City of Clintonville
Plan Commission Meeting
At Clintonville Community Center
30 S Main St
5:00 PM – Tuesday, October 13, 2026

To: City of Clintonville Plan Commission
From: Steve Tremlett and John Schwartz, MSA
Subject: Hoffmaster / Creative Converting Planned Unit Development – Combined General Development Plan and Specific Implementation Plan
Date: October 1st, 2026

Hoffmaster Creative Converting Division is requesting approval of a Planned Unit Development (PUD) for its existing manufacturing property at 255 Spring Street. This review is on a combined General Development Plan (GDP) and Specific Implementation Plan (SIP) to allow a rezone from I-1 Industrial to PUD.

Application for
**Planned Unit
Development (PUD) for**
Hoffmaster Development
City of Clintonville, WI

OVERALL SITE PLAN

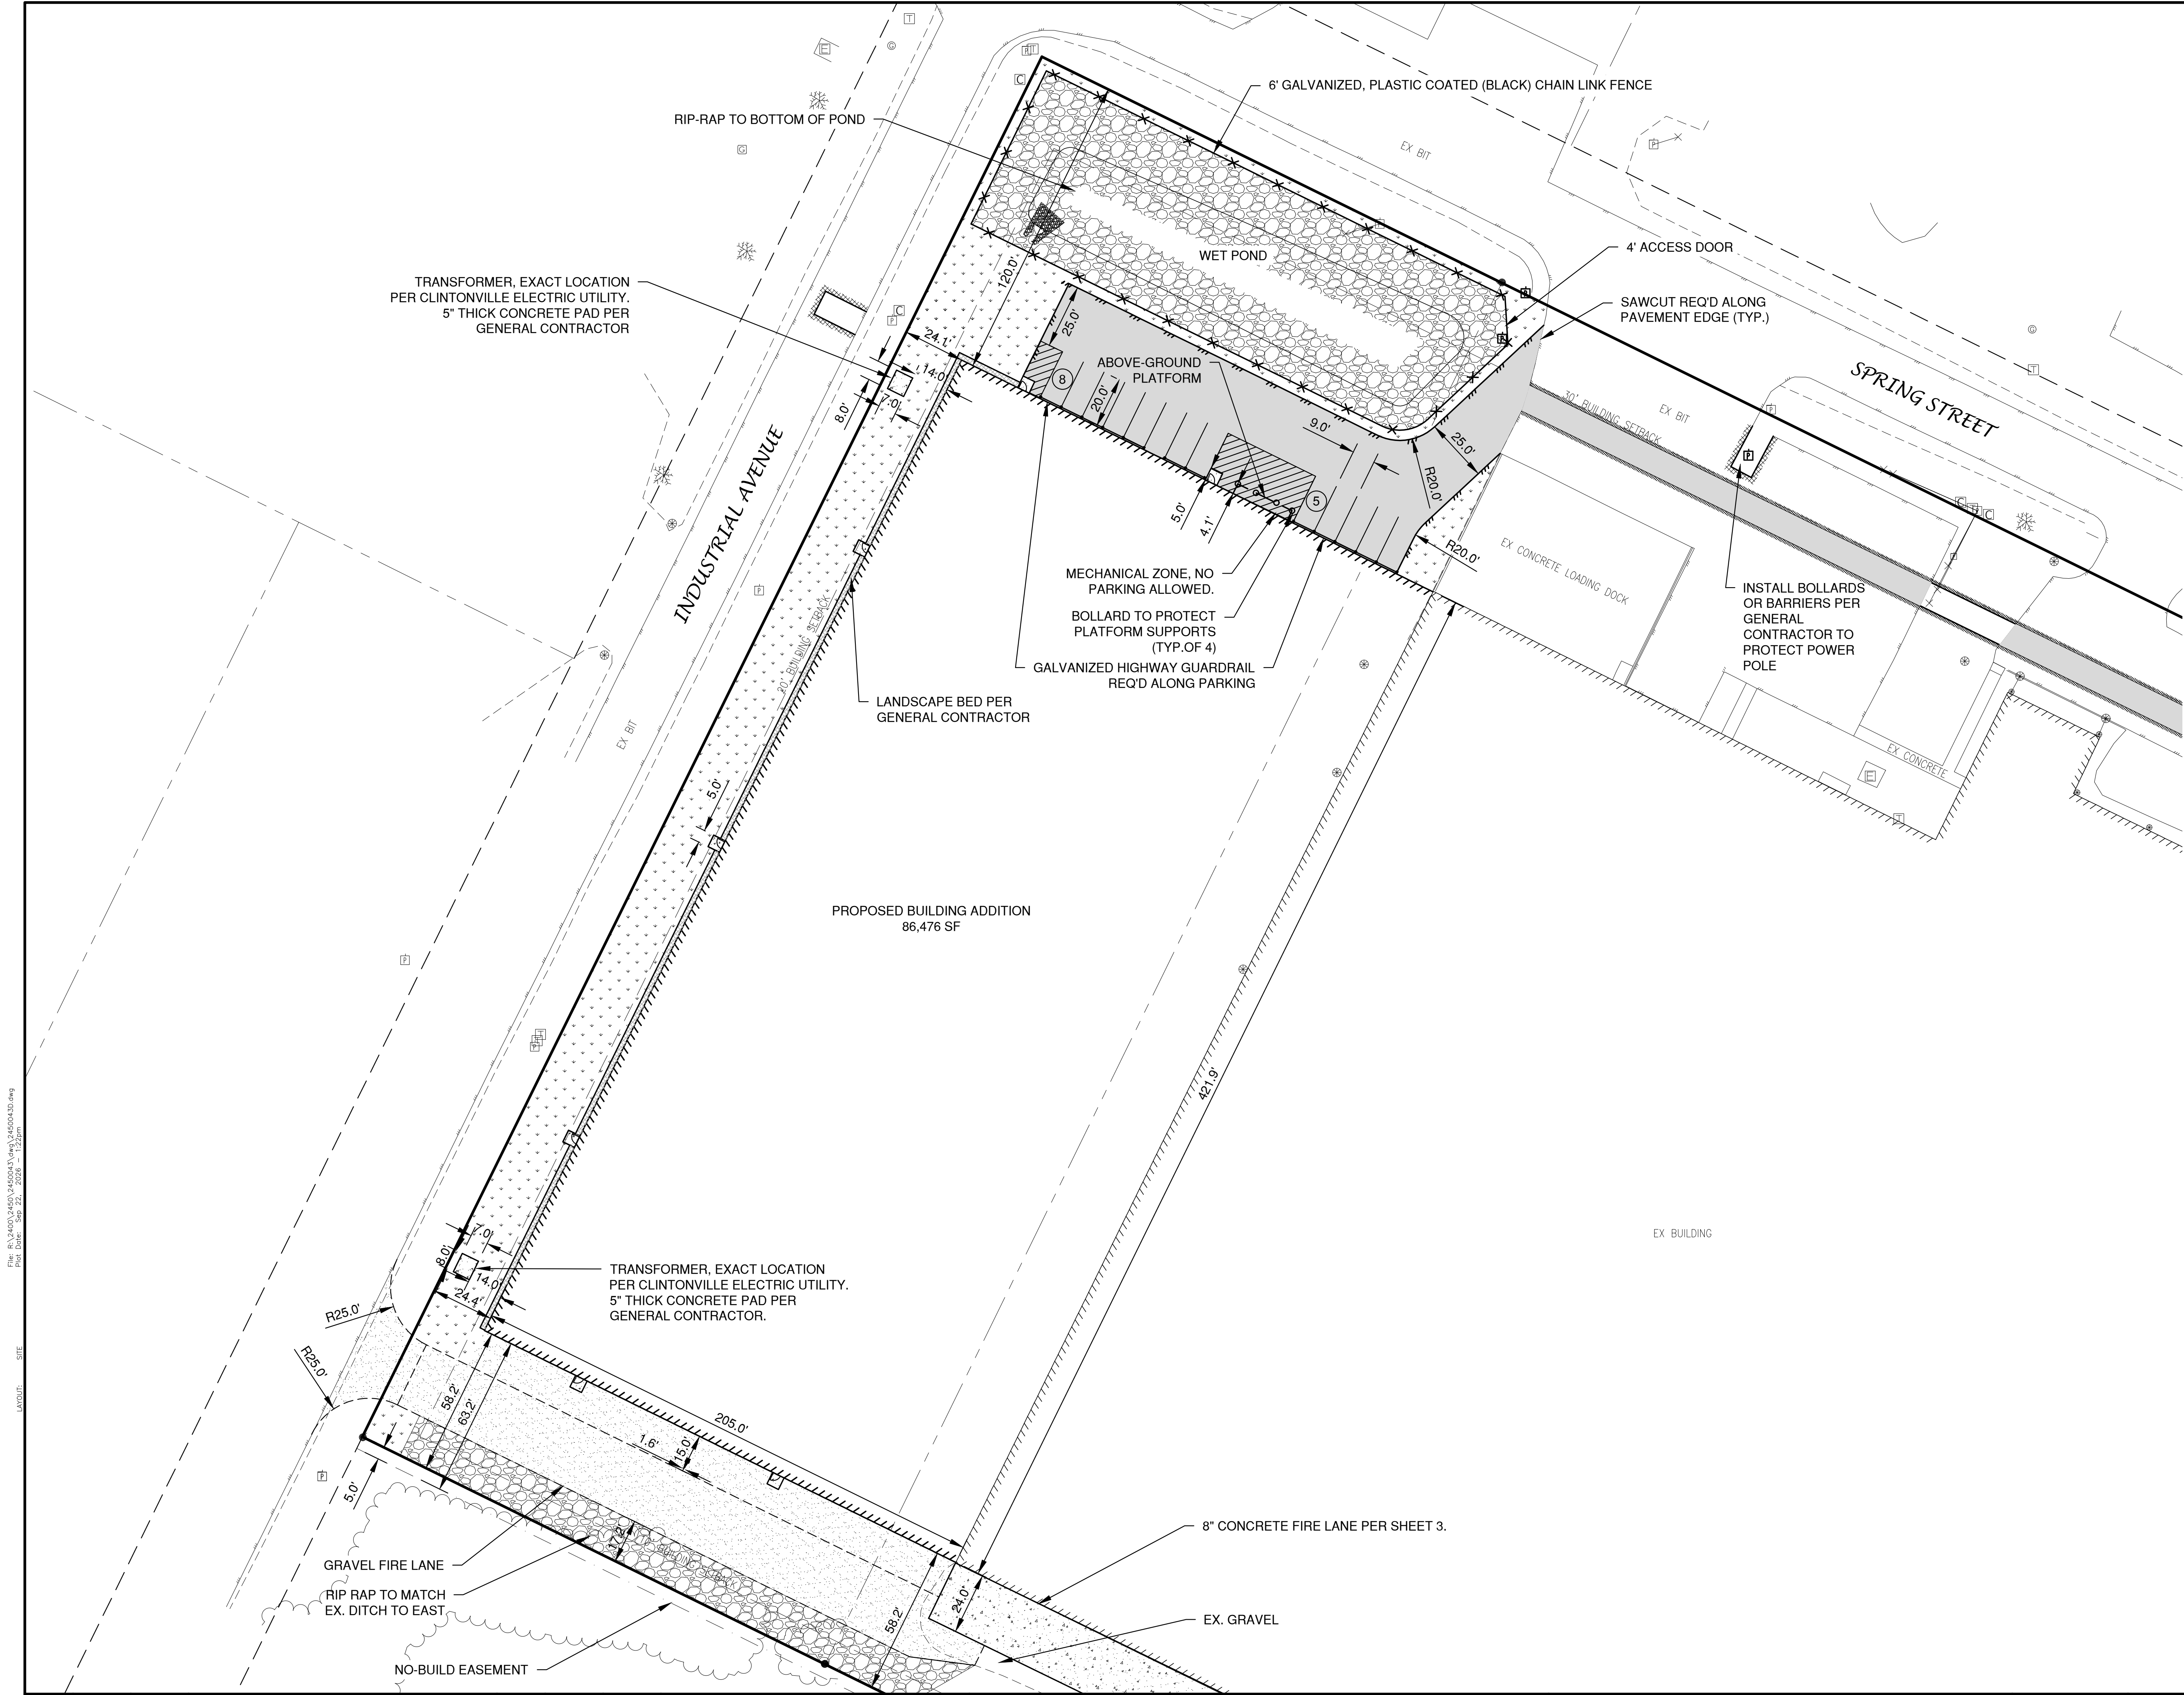
The Zoning Code defines lot area coverage as the area of a lot consisting of impervious surface in relation to the total lot area. The I-1 District establishes a maximum lot area coverage of **70%**. The submitted overall site plan identifies approximately 61.3% of the site as building area, 24.8% as asphalt/gravel/concrete area, and 13.9% as green space. Building area plus the identified paved/gravel/concrete area therefore represents approximately **86.1%** of the site.

The applicant requests that the PUD establish a maximum lot area coverage of **88%**, providing limited flexibility beyond the improvements presently depicted on the site plan. Development exceeding that standard would require the developer to come back for amendment review under the PUD amendment provisions.

The project proposes a new wet detention pond in the northwest portion of the property to serve the building addition and related pavement, together with a new bioretention pond serving the proposed northeast parking expansion. **The previously submitted stormwater management plan (not included in the document currently) did not evaluate the northeast biorientation basin. The applicant is stating the southeast improvement will be managed by the basin in an existing stormwater pond east of Staff Sergeant Warren Hansen Drive; however, the previous stormwater management plan has not been provided to confirm this improvement will not exceed the capacity of that pond.**

- b. Revise Section 3 of the GDP to be called “GDP Standards and Project Plan”. Add the following sentence: “The development shall follow I-1 Industrial zoning district standards, except increasing lot area coverage from 70% to 88% and increasing the building height maximum from 35 feet to 40 feet by right. Other City code requirements shall apply if not explicitly identified in this document.”
 - c. Remove the last sentence under Section 1.
 - d. Include Stormwater Management Plan(s) as an appendix.
- 2. Prior to issuing an occupancy permit, a stormwater management plan(s) shall be approved by City that covers all improvement project areas.
- 3. Engineer review and acceptance of construction plans for parking lot improvements in the northeast and southeast is required before constructing said improvements.
